BAYSIDE COUNCIL

Planning Assessment Report

Panel Reference	2018SCL003
DA Number	DA-2017/1236
LGA	Bayside Council
Proposed Development	Integrated Development for the demolition of three existing buildings, construction and use of the site for two residential flat buildings six (6) and eight (8) storeys comprising of ground floor retail tenancy fronting Gardeners Road, with 109 apartments, rooftop communal open spaces to each tower, two level of basement car parking to accommodate 123 spaces and associated landscaping and diversion of the Sydney Water Sewer Main.
Street Address	551,553,555-559 Gardeners Road, Mascot
Applicant/Owner	Applicant: Bravo Global Pty Ltd C/-Urbis Pty Ltd Owner: Bravo Global Pty Ltd
Date of DA lodgement	7 December 2017
Number of Submissions	First notification period: 8 Second notification period: 10 Third notification period 3
Recommendation	It is RECOMMENDED: <ol style="list-style-type: none"> 1. THAT the Sydney Eastern City Planning Panel considers the Clause 4.6 request to vary the height development standard in Clause 4.3 of Botany Bay Local Environmental Plan 2013 and can be satisfied that the variation will result in consistency with the objectives of

Figure 4: Plan extract (Level 06)

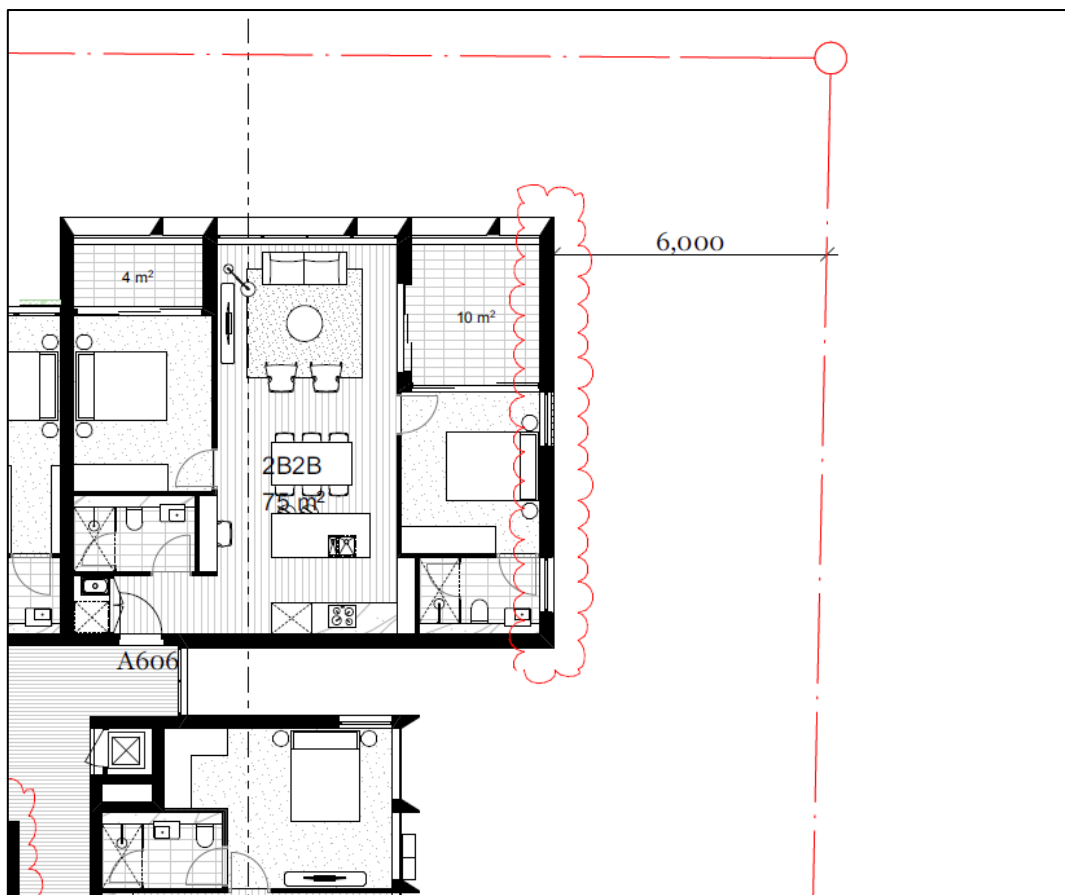
The proposed setbacks to the eastern side boundary range between 6m – 9m and comply with the ADG requirements with the exception of the north-eastern portion of the development at the front of the site. This building element (shown below) is proposed to be setback 6m on all levels. The ADG requires a 9m setback for 5-8 storeys.

Figure 7: Section drawing showing separation distances

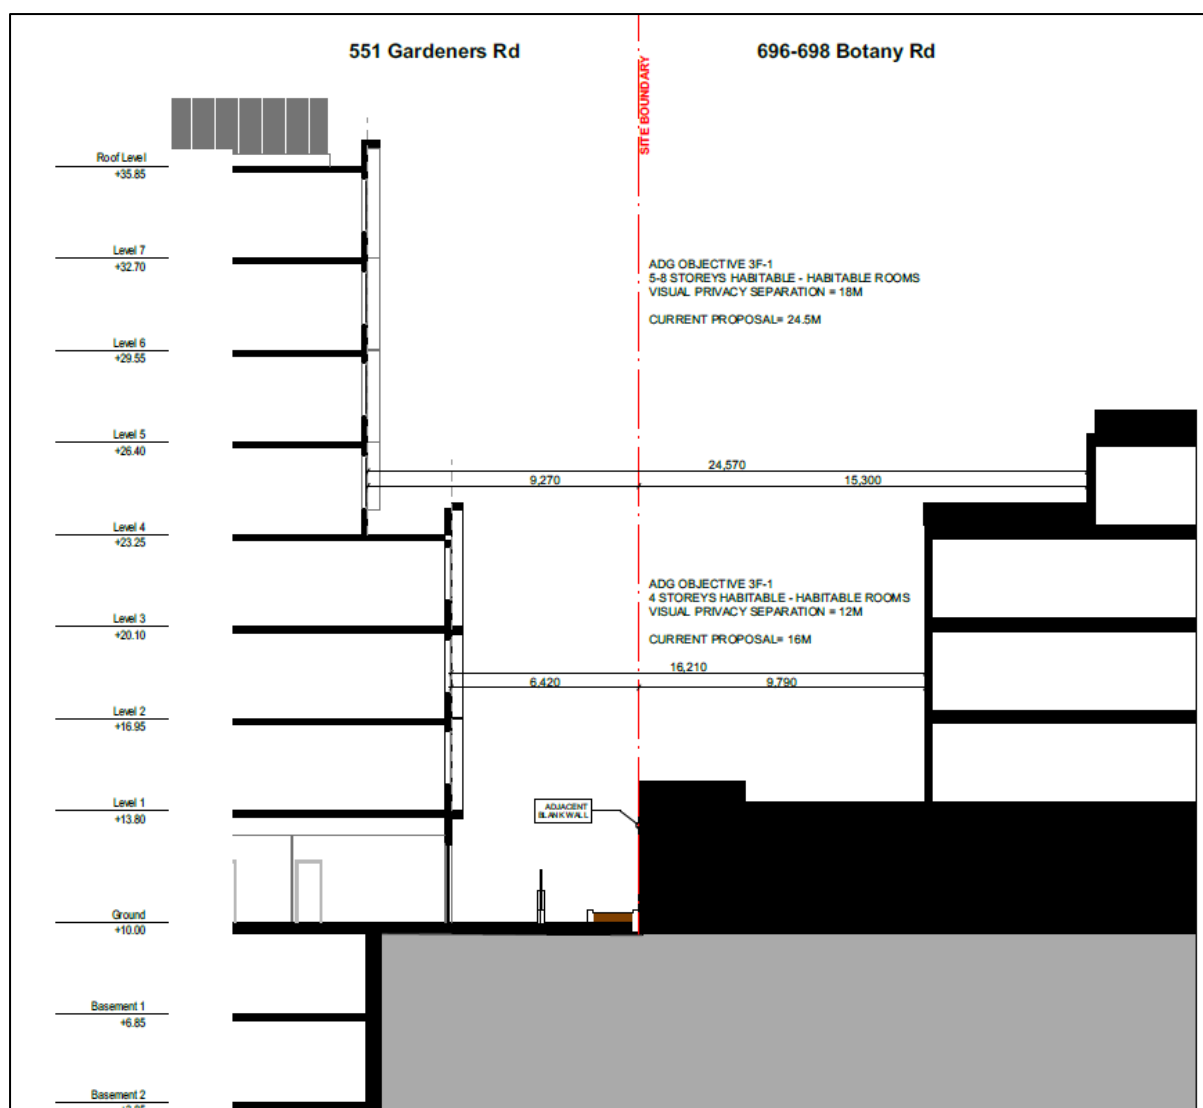
Some of the concerns raised relate to building separation, visual bulk and scale and privacy impacts. The proposal exceeds the ADG building separation controls, as it relates to the building at 694 Botany Road. The proposed development accommodates a 16m+ separation at the first 4 levels and 24.5m separation for levels 5 and above. The applicant has prepared a section drawing (re-produced below) which demonstrates the relationship between the two buildings:

Figure 9: Section-A extract

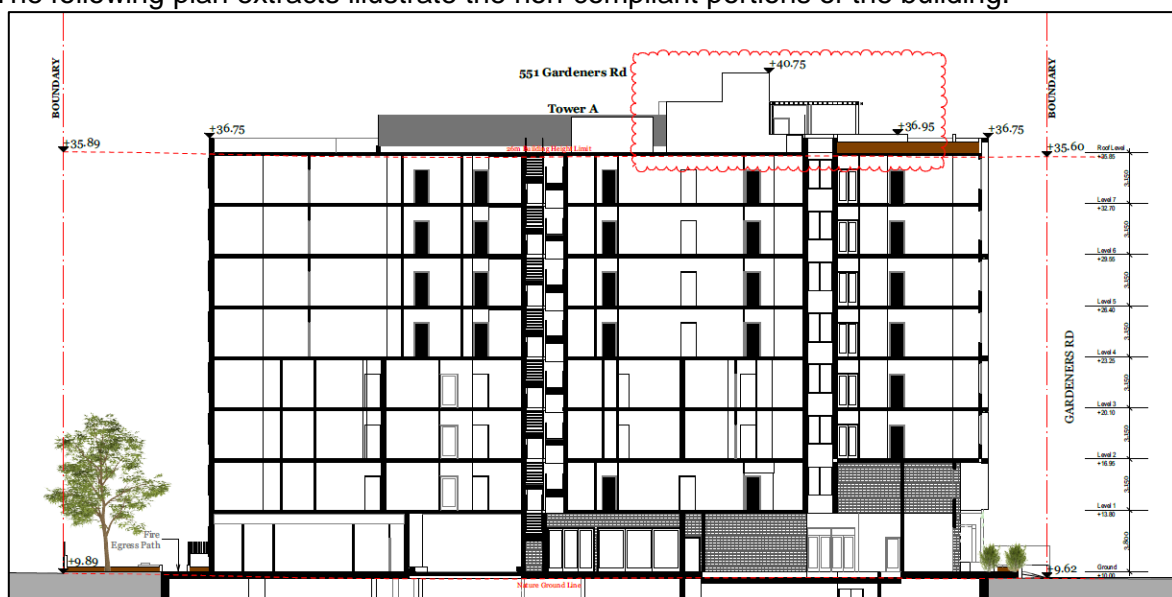
The proposed development does not comply with the building height development standard of 26 metres under BBLEP 2013. The highest part of the proposed development is 30.86m when measured to the top of the lift overrun in Tower A. The extent of the breach is therefore 4.86 m or 18.6%.

As can be seen from Figures 9 - 11 above, the non-compliant building elements relate to the rooftop communal area, lift overrun/fire stairs, some portions of the top building parapets, rooftop plan/services area and the screens which surround it.

Figure 12: East elevation extract of No.563 Gardeners Road with height line shown in red

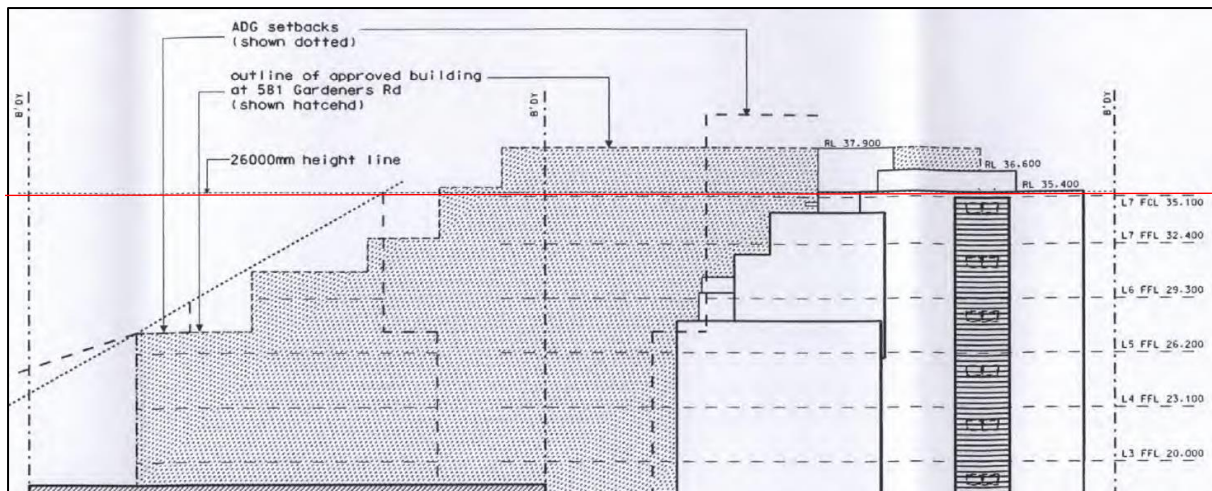
The building height breach facilitates equitable access to a rooftop communal open space area. Whilst there are other communal open space areas proposed (on the ground floor plan and on the rooftop of Tower B), the area above Tower A is north facing, is likely to have significant view availability and provides a high level of amenity for future users. As identified in the applicant's clause 4.6 exception, a similar height non-compliance has been approved on the neighbouring site to the west at No.563 – 567 Gardeners Road. The top portion of the building/parapet, rooftop communal terrace, fire stairs and lift were approved above the 26m building height. Refer to plan extract below:

Having regard to the above, it is evident that Council has not strictly enforced the maximum allowable building height control in past decisions.

Figure 13: Site Line diagram

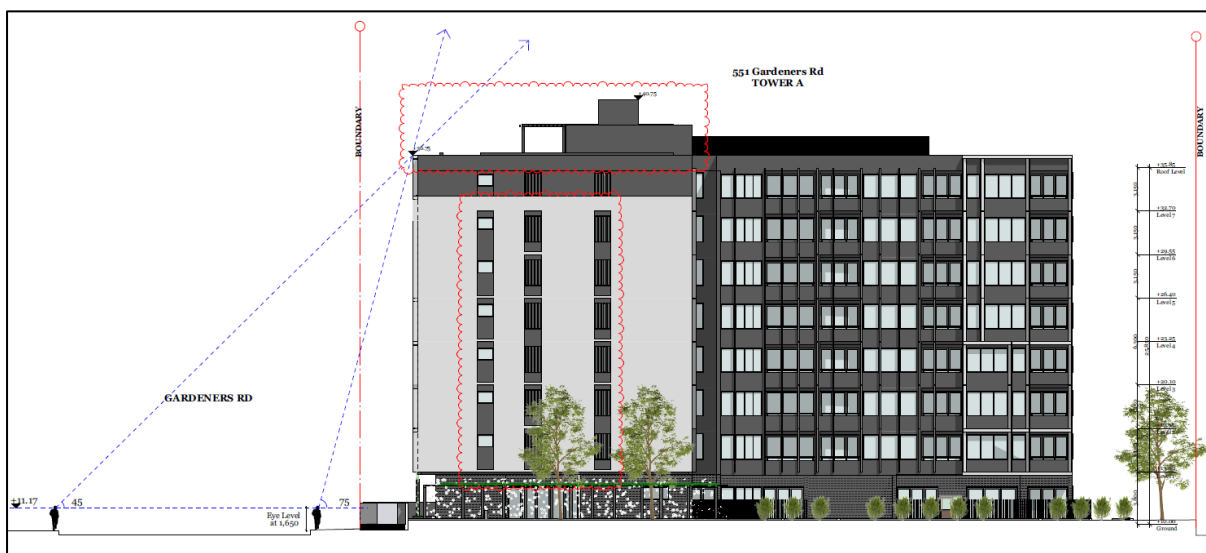
The applicant has provided a sight line diagram which demonstrates that the building elements in breach of the maximum allowable height would not be readily visible from the public domain at the front of the site (i.e. – from Gardeners Road). Refer to plan extract below:

It is noted that the height of screening around the rooftop services in Tower A appears to cause very marginal additional overshadowing impacts to bedroom windows on the uppermost level in the development at No.696-698 Botany Road. As a result of this, a condition of consent is recommended to reduce the height of the screening from approximately 2.3m to 1.6m.

61. The height of the screening around the Services on the Roof Plan (Tower A) shall be reduced to a maximum height of 1.6m.
62. Construction details of installation of proposed green façade/wall on North Elevation prepared by a wall garden specialist. Also include Irrigation system and maintenance Schedule with requirements to ensure long term of green wall. Maintenance schedule shall comprise installation period and ongoing maintenance requirements.
